Corrigendum No. 3 to IFB No. CPI9725P19

Engineering, Fabrication and Supply of Modular Instrumentation Packages for OCS at Nadua and GGS at East Khagorijan in Dibrugarh district, Assam

Annexure - I

SUMMARY OF CONSULTANT/OIL'S RESPONSE TO PRE-BID QUERIES

DRAWING NO.: 17039-ND-E-DW-9002 REV: D SHEET: 03 of 04 SCALE: NTS

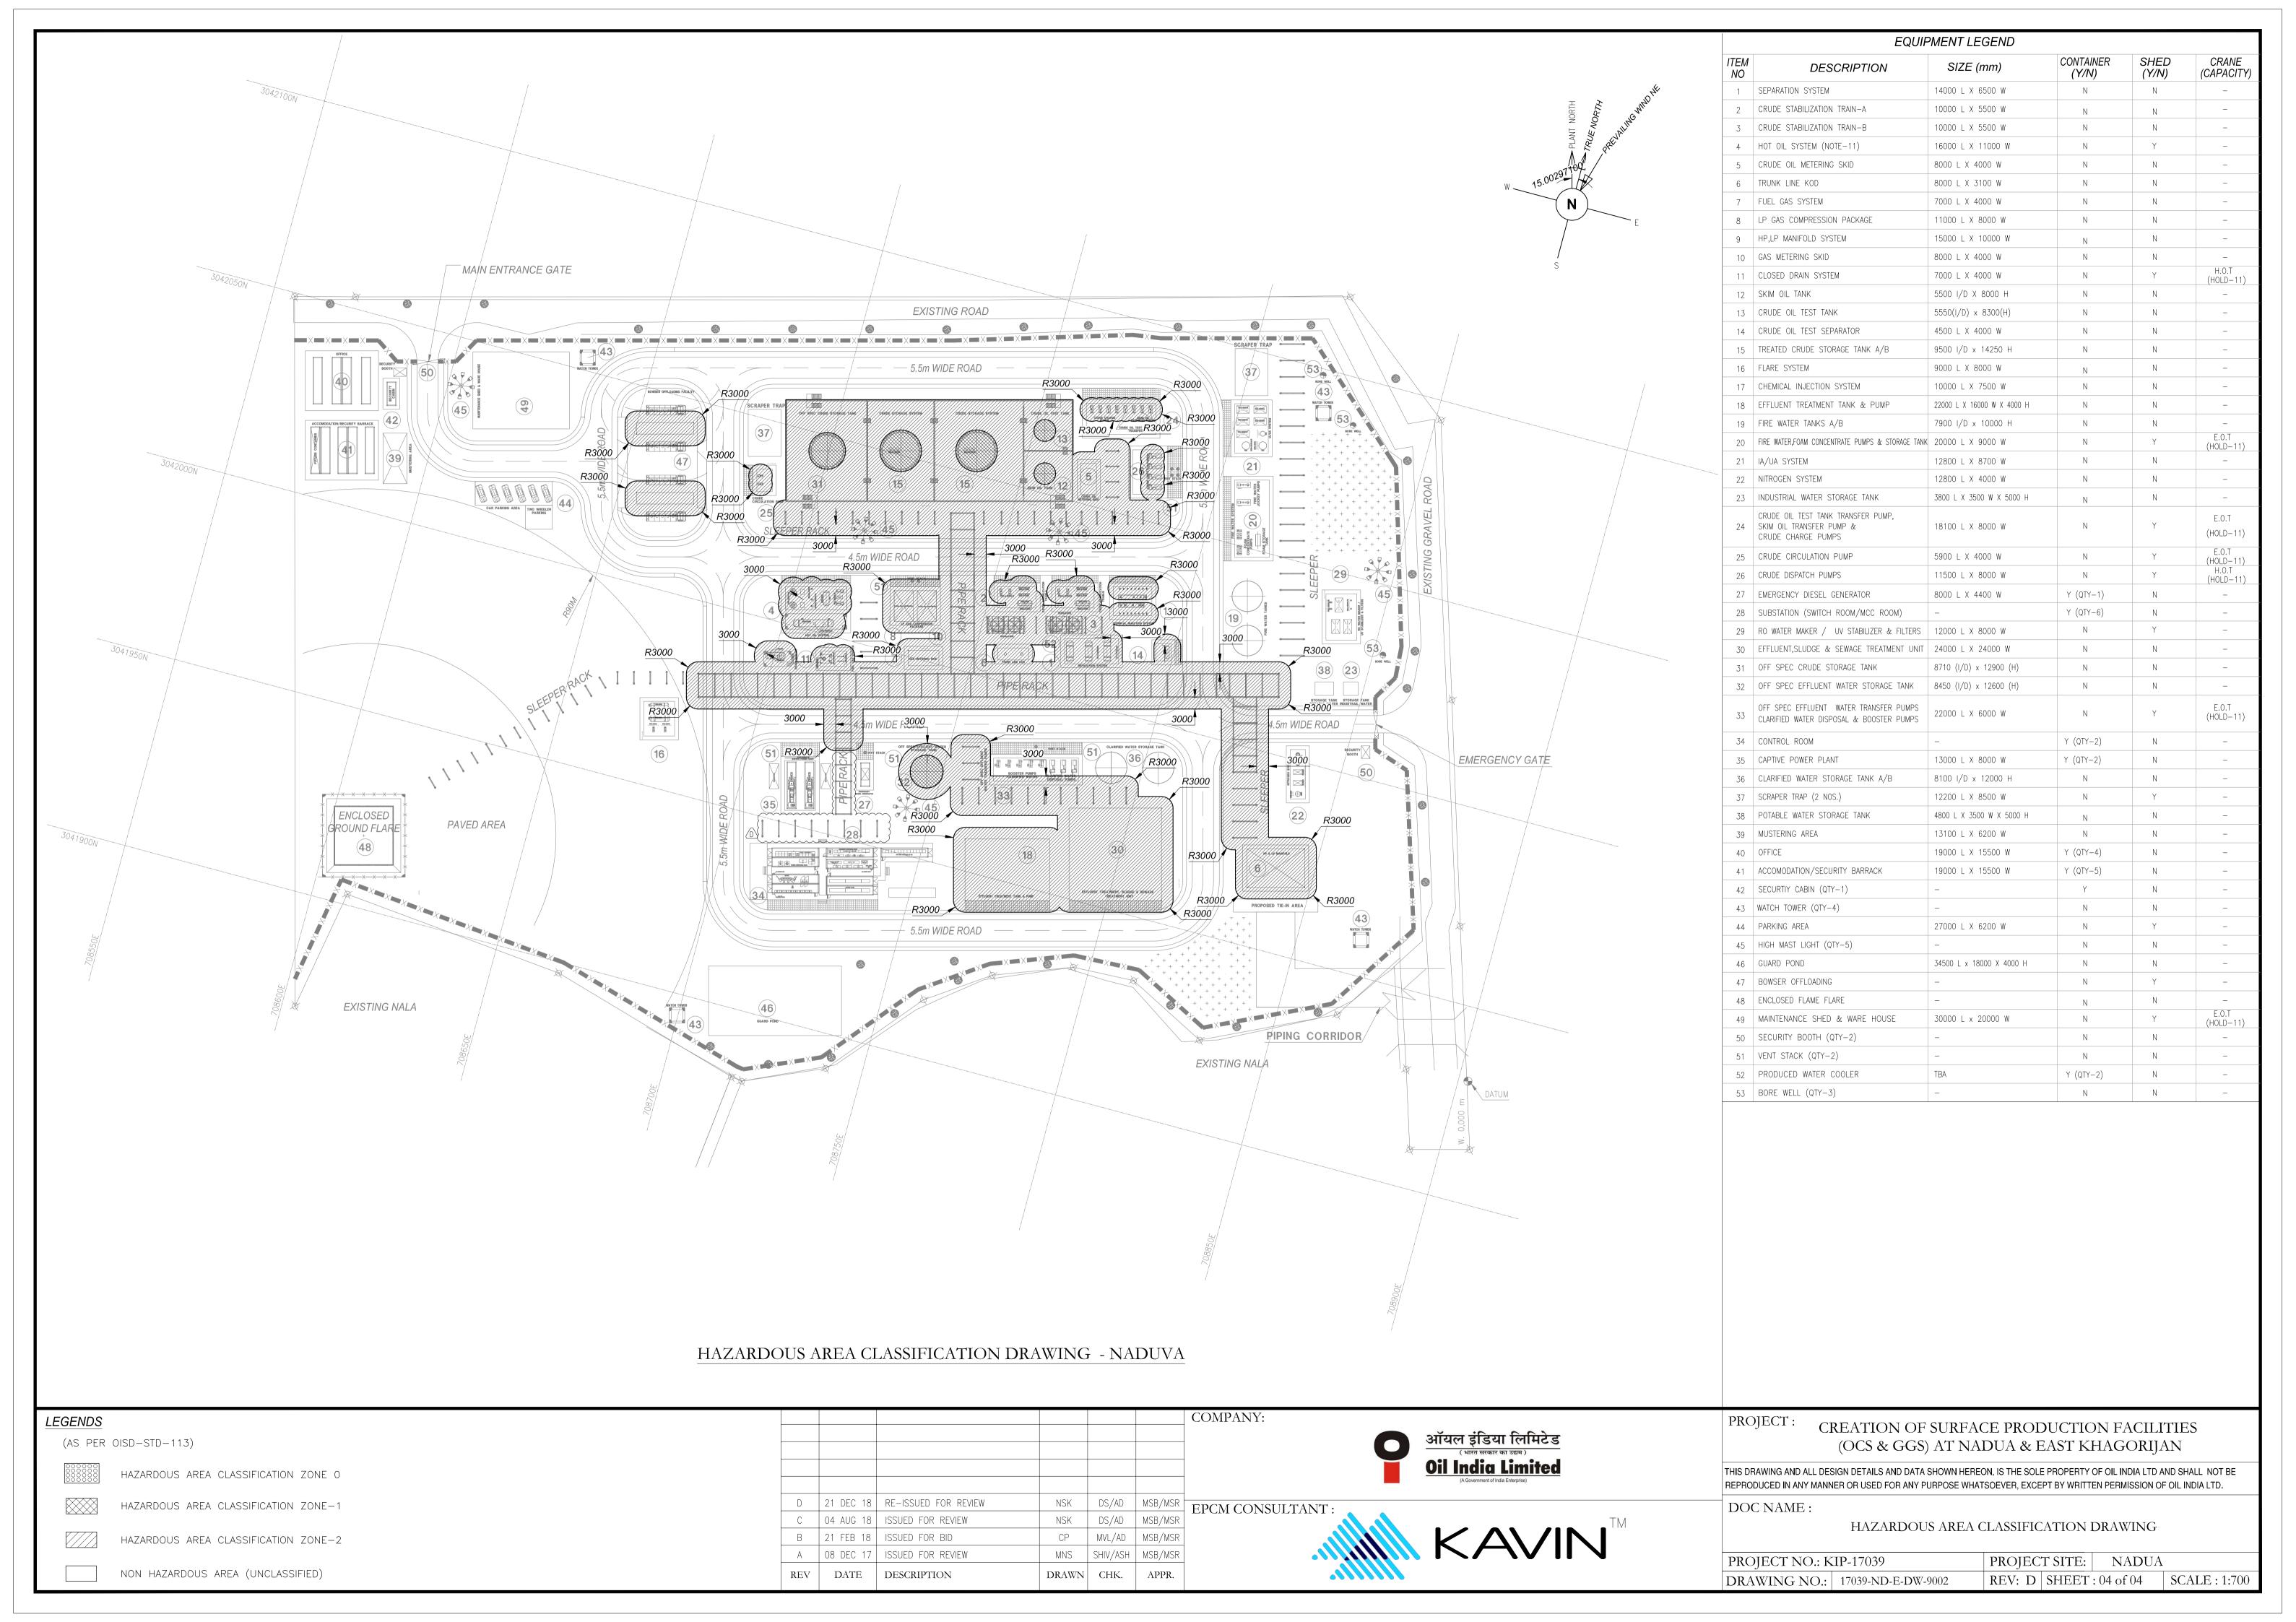
6.	General	-	Zone classification details	Bidder shall refer to Hazardous Area classification drawing attached.			
7.	General	-	Design Basis for cable sizing	Bidder shall follow IEC standard

16.	General	-	The containers are shown in safe areas; however cable duct is shown passing through Zone-2 area. We understand that Zone-2 compliant cable duct are not available in the market place.	Bus duct is in safe area. Bidder shall refer the latest Hazardous area classification drawing attached.
